NOV_SCE_ATJ_ 20211207-01

Southern California Edison

NOTICE OF VIOLATION

Report Name: ATJ_SCE_20211207-01

Structure ID: 1026956E

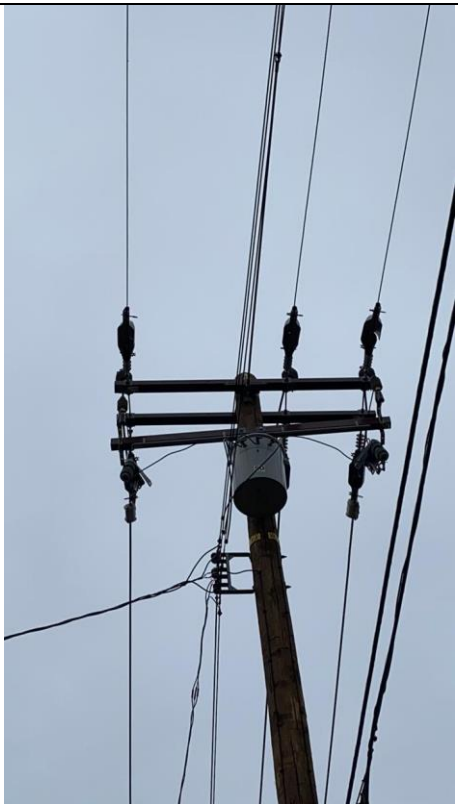
Item14IA1mg1: No vibration dampers

Structure ID: 1789149E

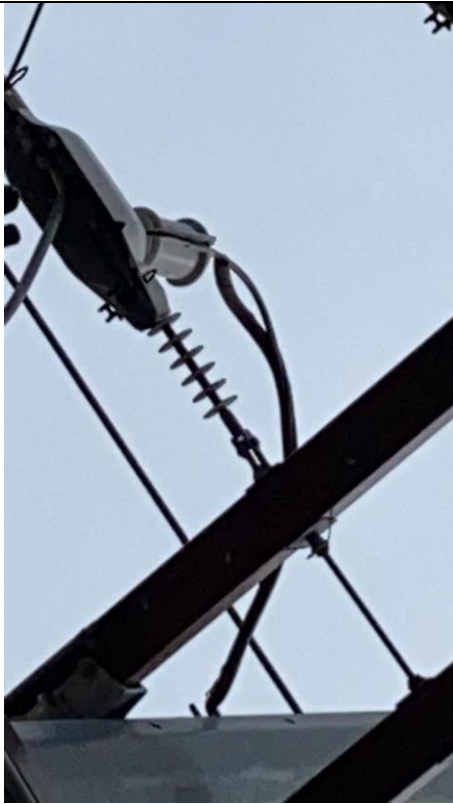
Item16IA2img1: No vibration dampers

Item16IA3Img1: Covering falling off covered jumper cable

Item16IA4Img1: Loose dead-end clamp
